WELL NO. Cisco Federal #14

APPLICATION FOR PERMIT TO DRILL, DEEPEN, OR PLUG BACK

USUAL ENVIRONMENTAL ASSESSMENT

LOCATION PLAN FOR CISCO WELL NO. 14 T. 20S., R. 23 E., Sec. 26		
	MINERALS SERVICE COMPANY GRAND JUNCTION, COLORADO		
APPROVED BY	SCALE	DRAWN BY	JOB NUMBER
STAKED BY	DATE	CHECKED BY

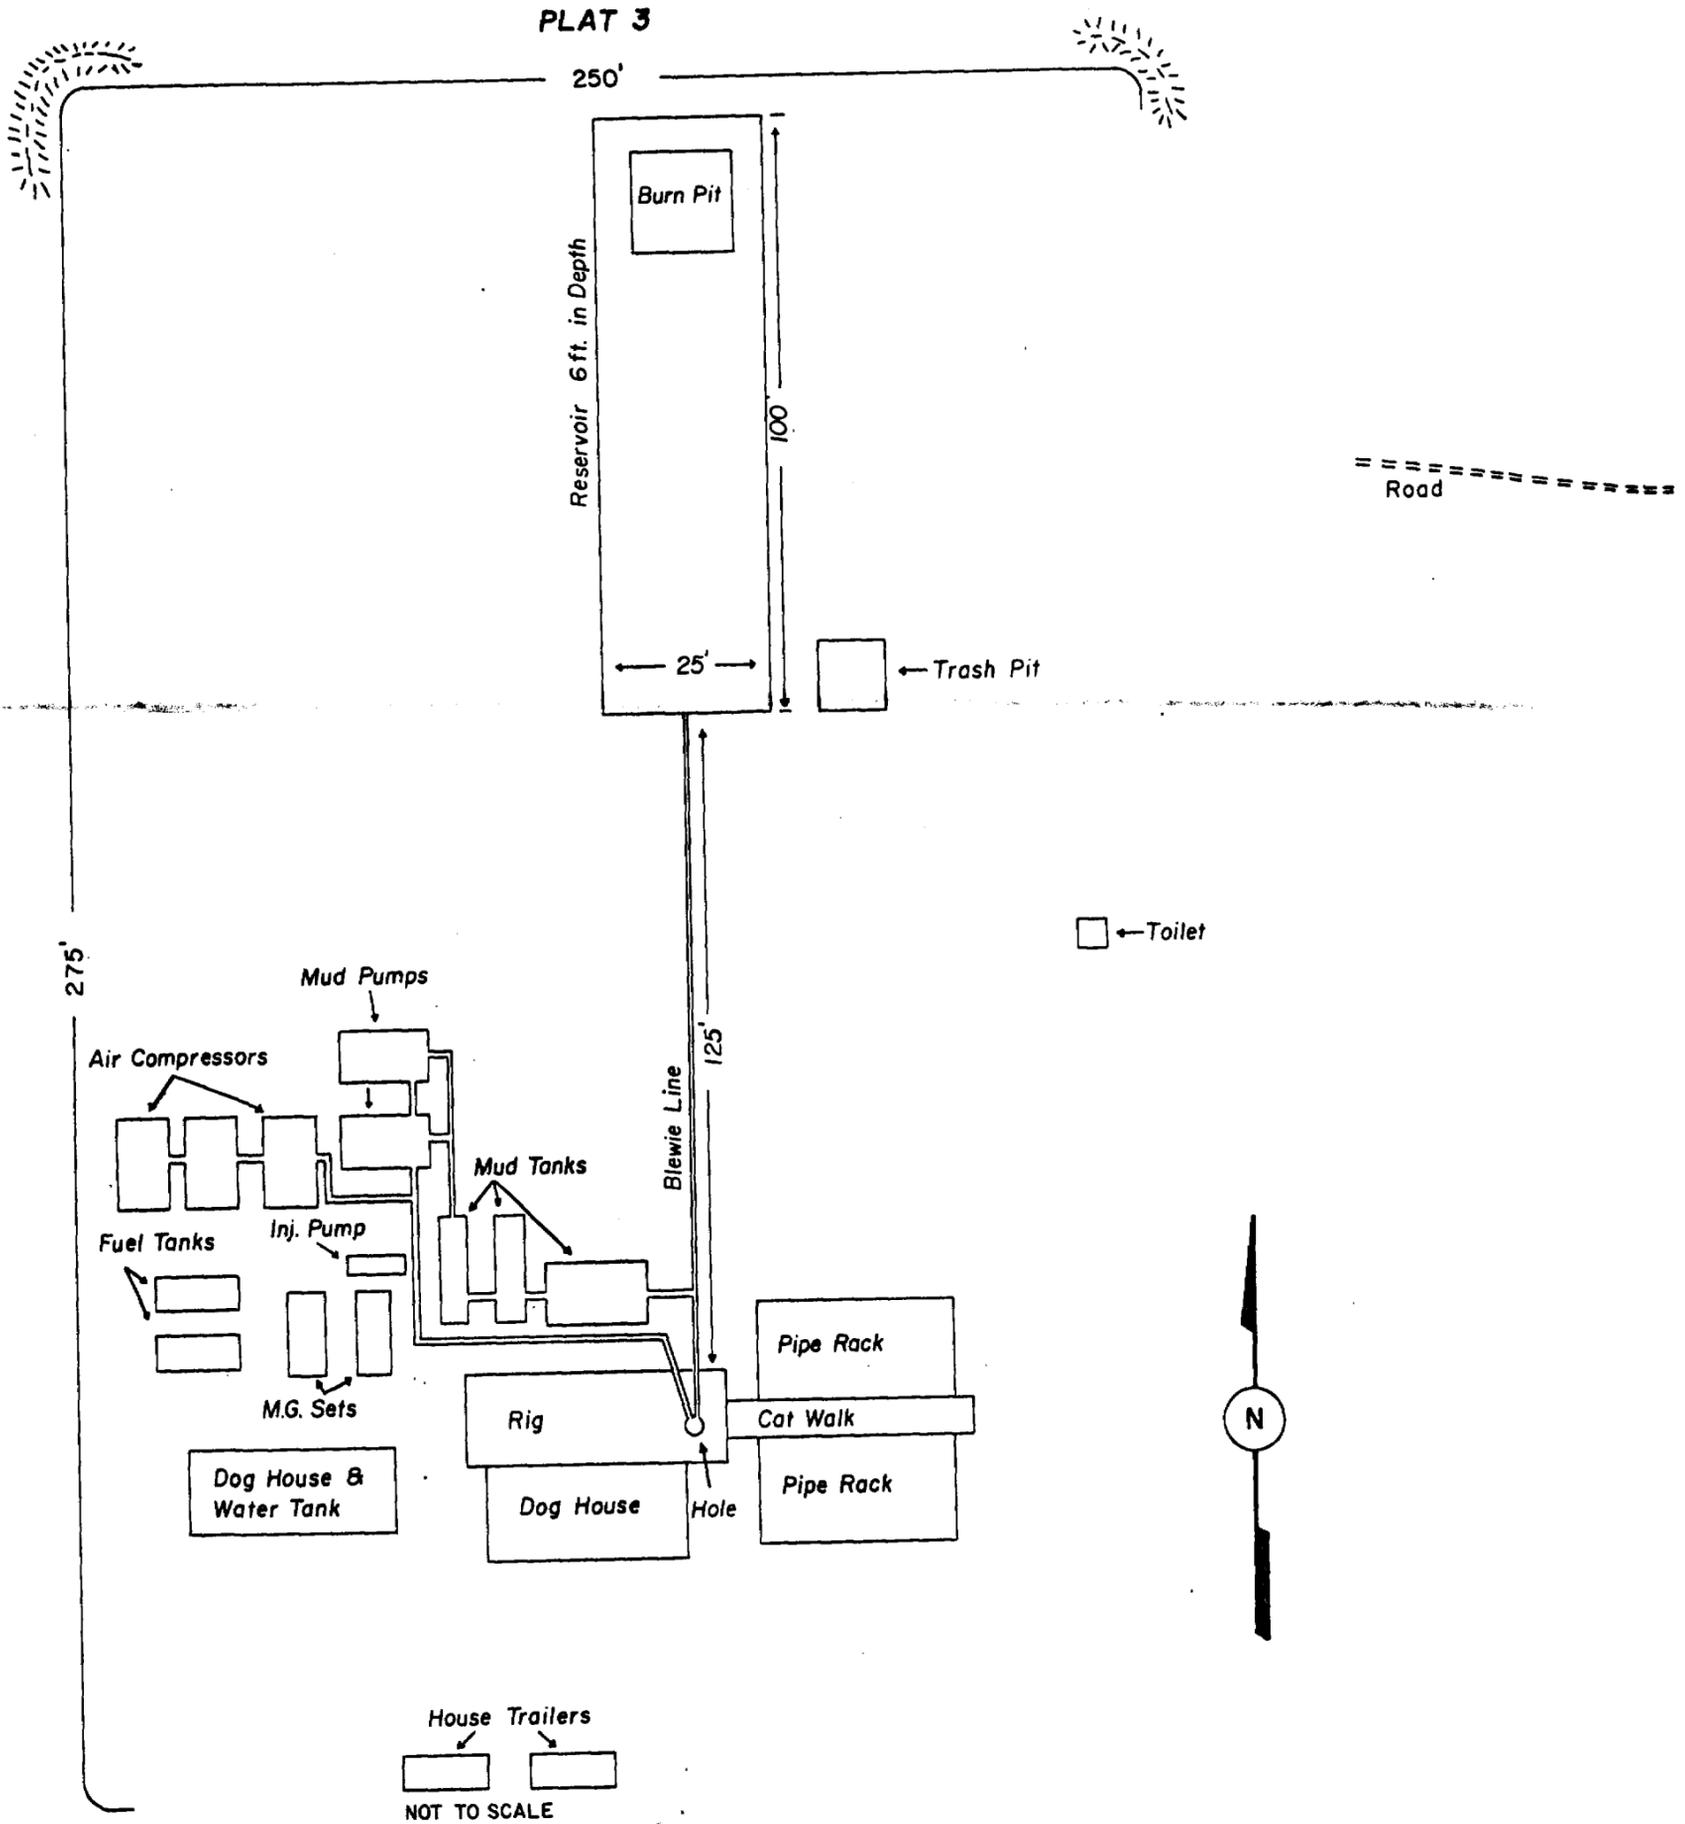
The location was rotated clockwise 110° east of north in order to locate the reserve pit in at least one-half cut material.

- 1) Original wellsite layout places reserve pit in fill material.
- 2) Both cattle and sheep could be endangered by toxic or hazardous fluids in the reserve pit if it is not properly fenced.

- 1) By rotating the well pad clockwise 110° east of north and by shortening and deepening the reserve pit, the well pad would then be located in a small ridge of cut material, thus improving chances for a competent reserve pit.
- 2) By fencing the reserve pit on three sides prior to drilling, and on the fourth side once the rig moves off, hazards posed by fluids to livestock and wildlife would be mitigated.

1. See attached Lease Stipulations. *None*
2. See attached BLM Stipulations.
3. Rotate well pad clockwise 110° east of north.
4. Shorten and deepen reserve pit to 12' x 12' x 60' dimensions.
5. Fence reserve pit on three sides prior to drilling, and on the fourth side once the rig moves off.

Rotate the pad north <sup>110°</sup>20 degrees east.
